Site Instruction

SI 24

PROJECT : Hampton Manor
PROJECT No : 1136.13
DATE : August 14, 2018

Title: Removal of Insulation behind Precast

1:20 A605

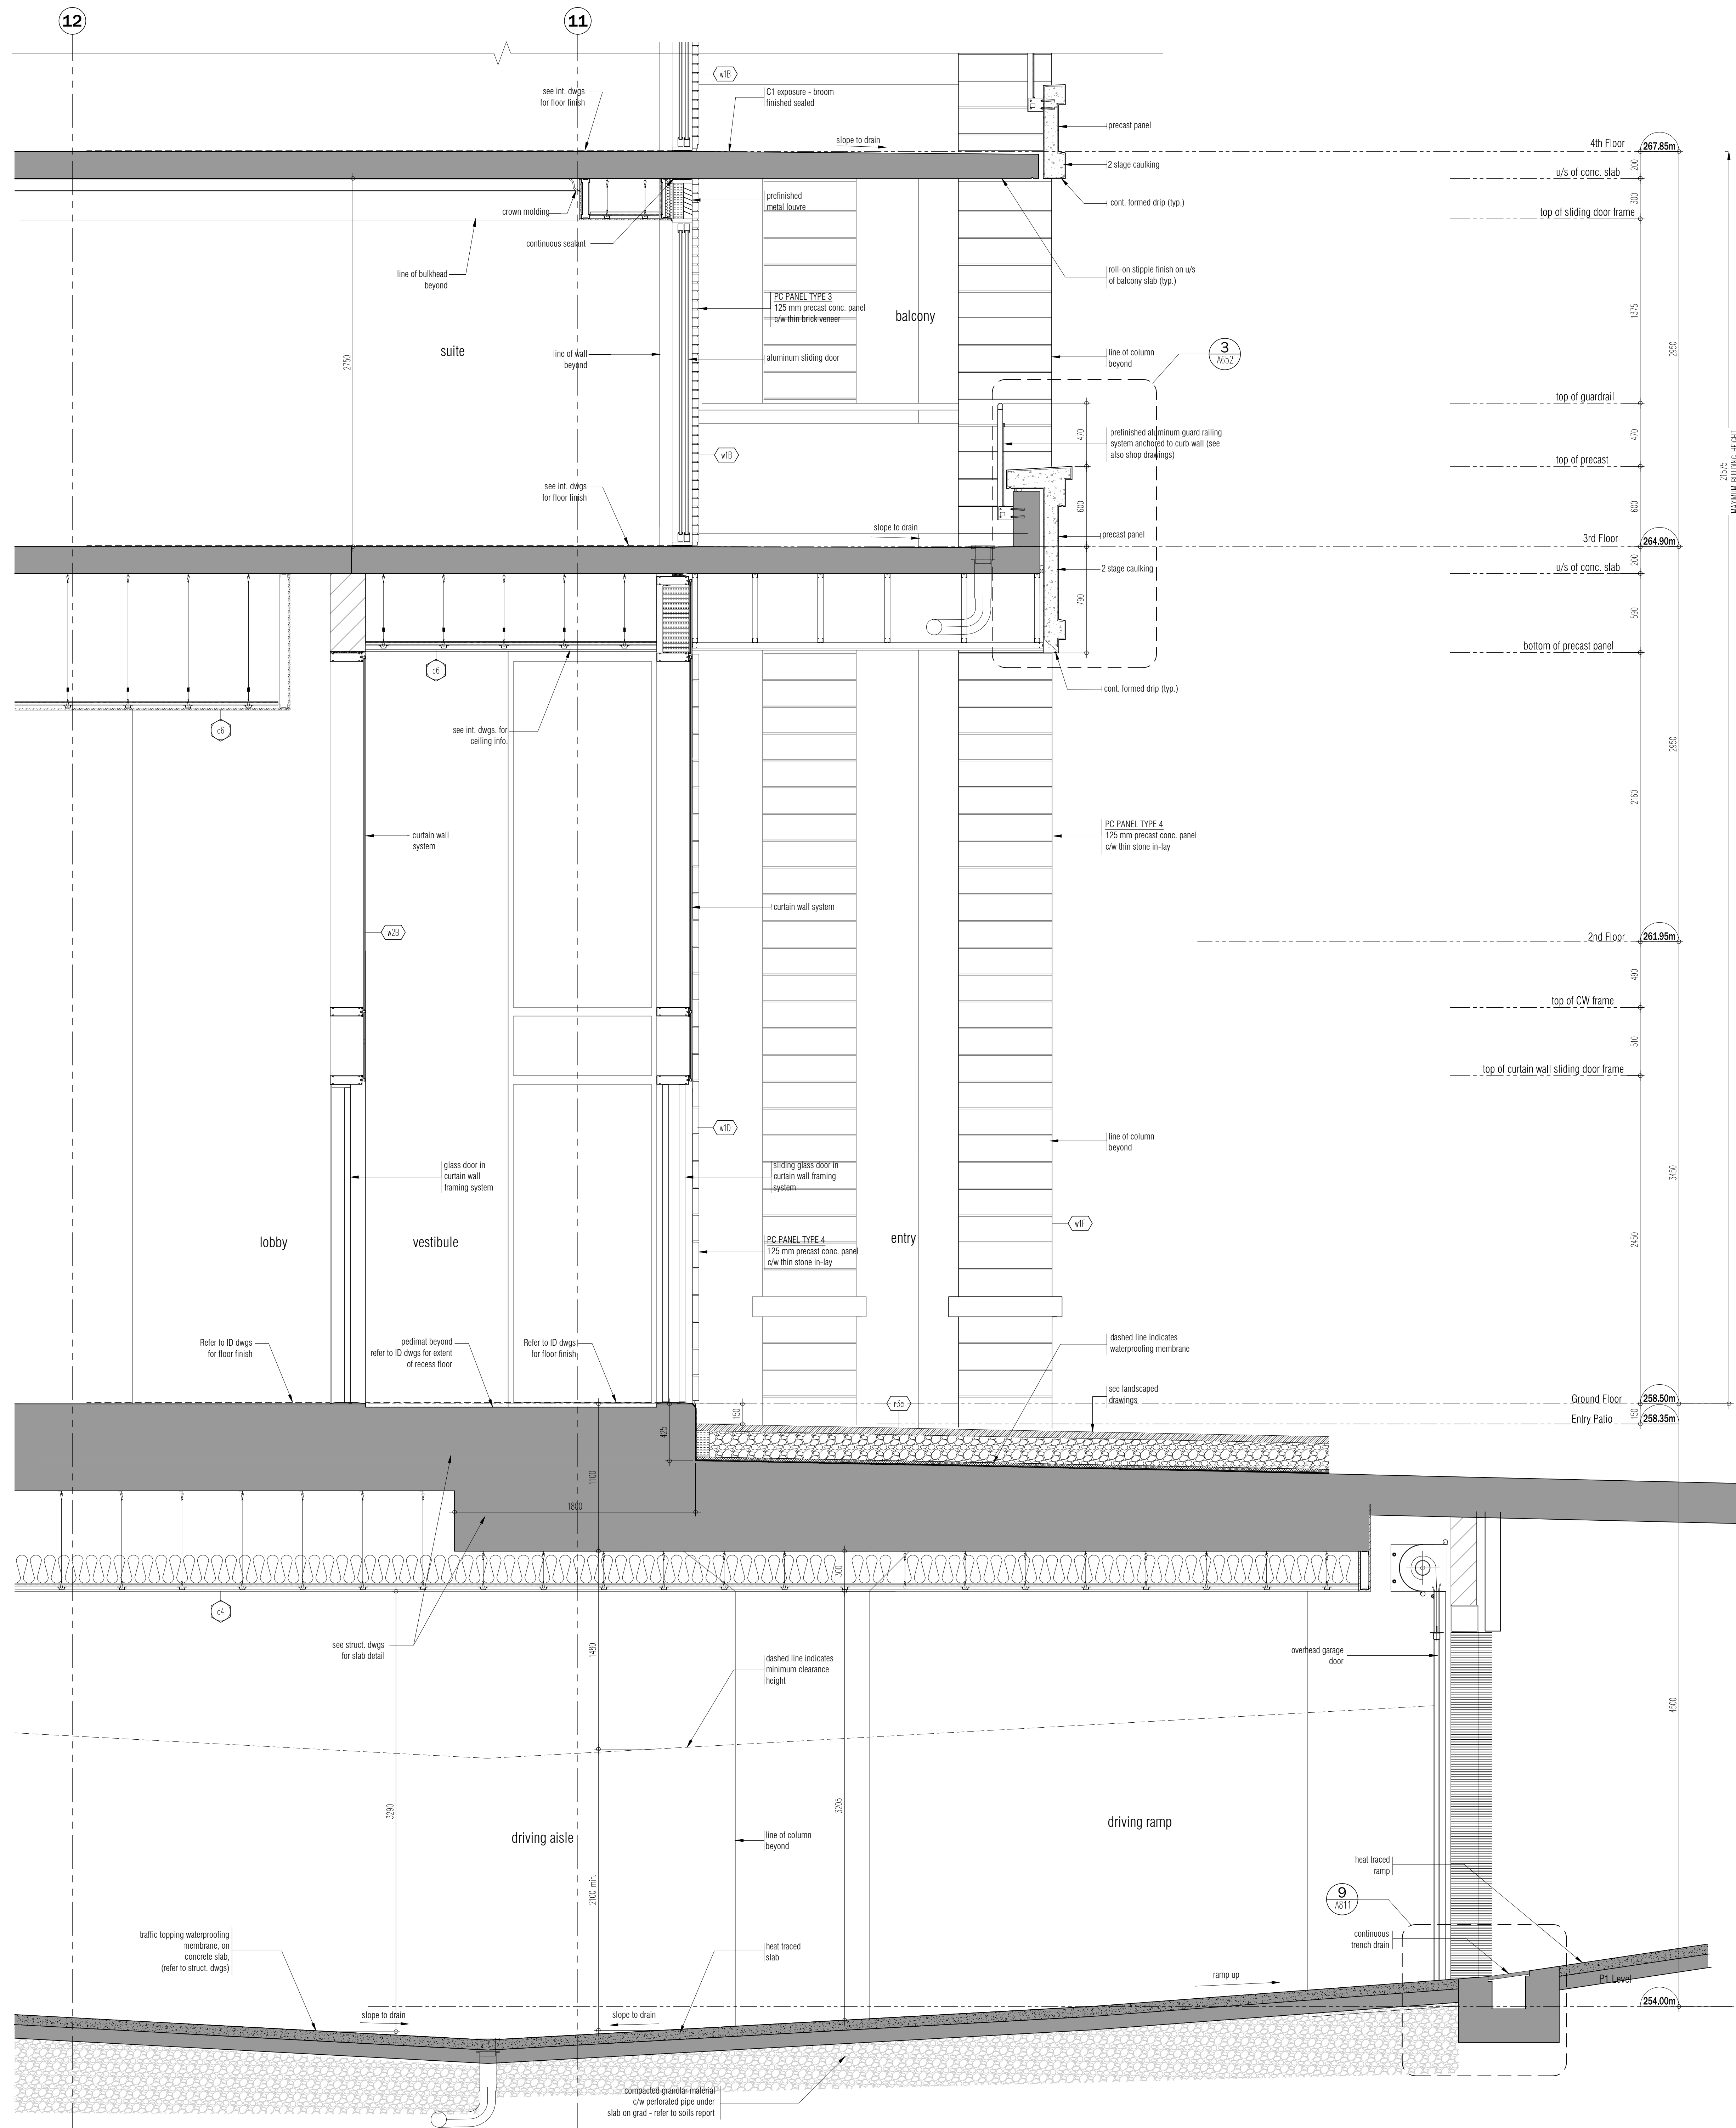
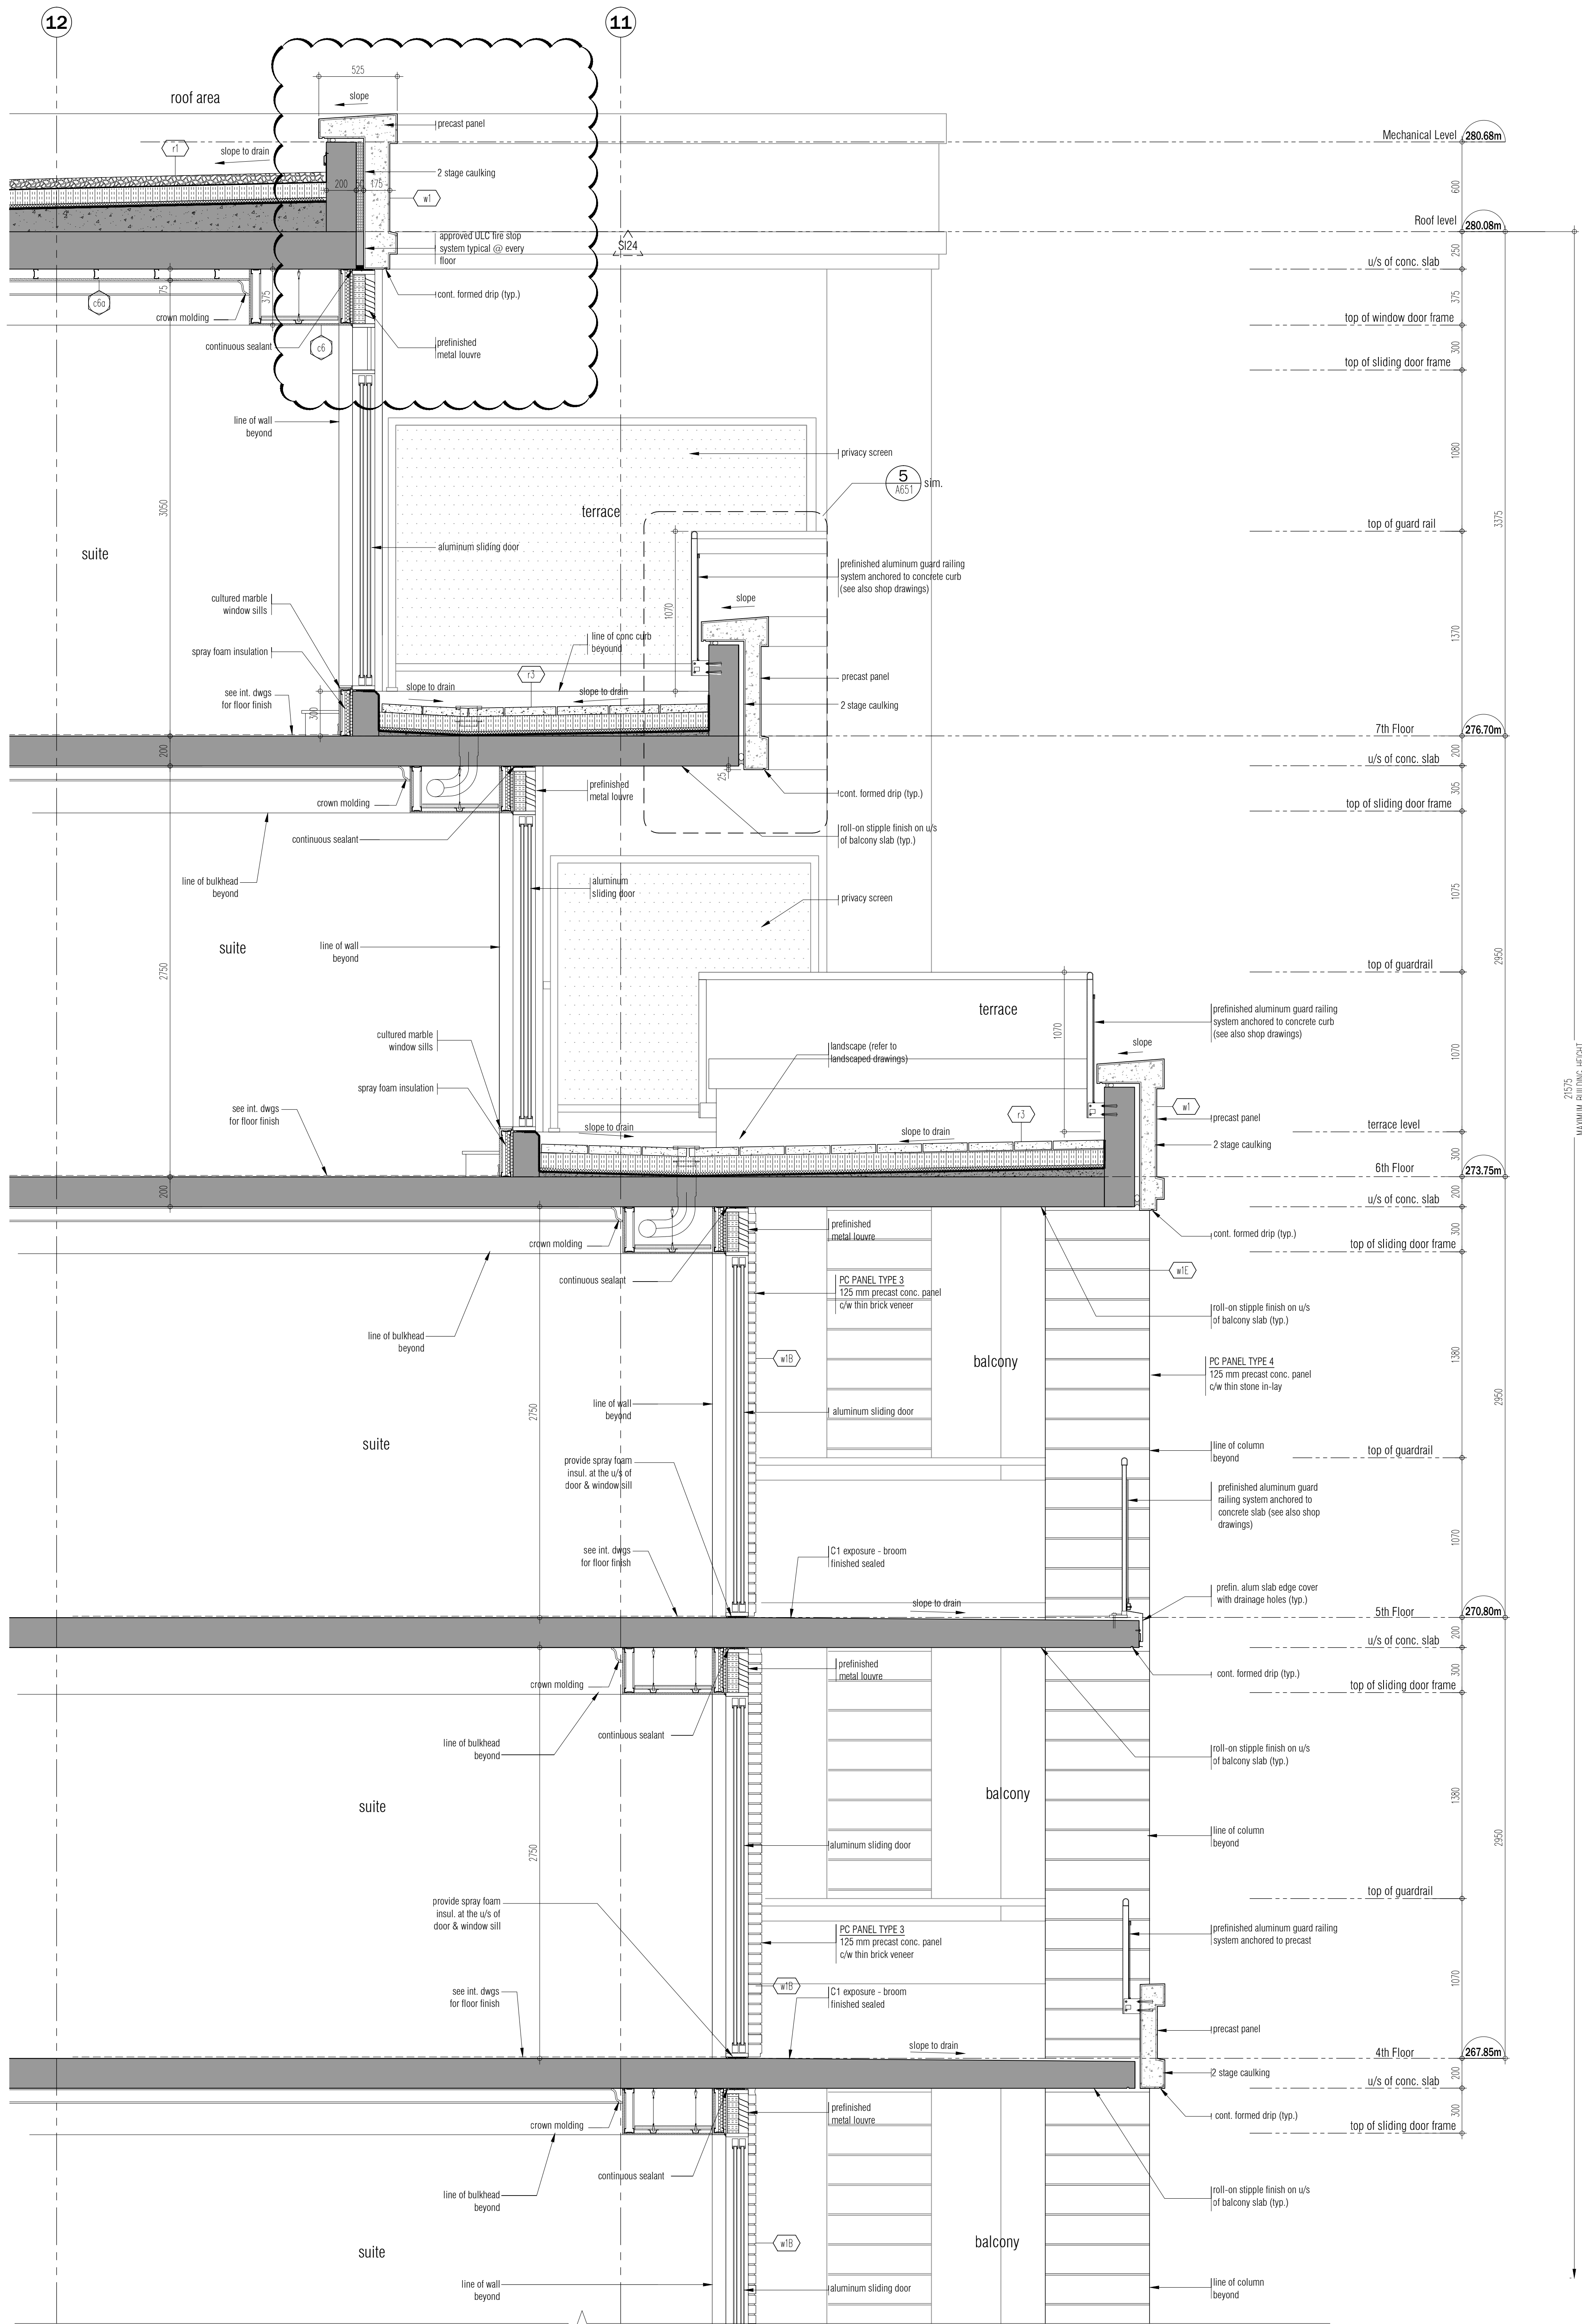
- Removal of insulation behind precast at terraces and roof.
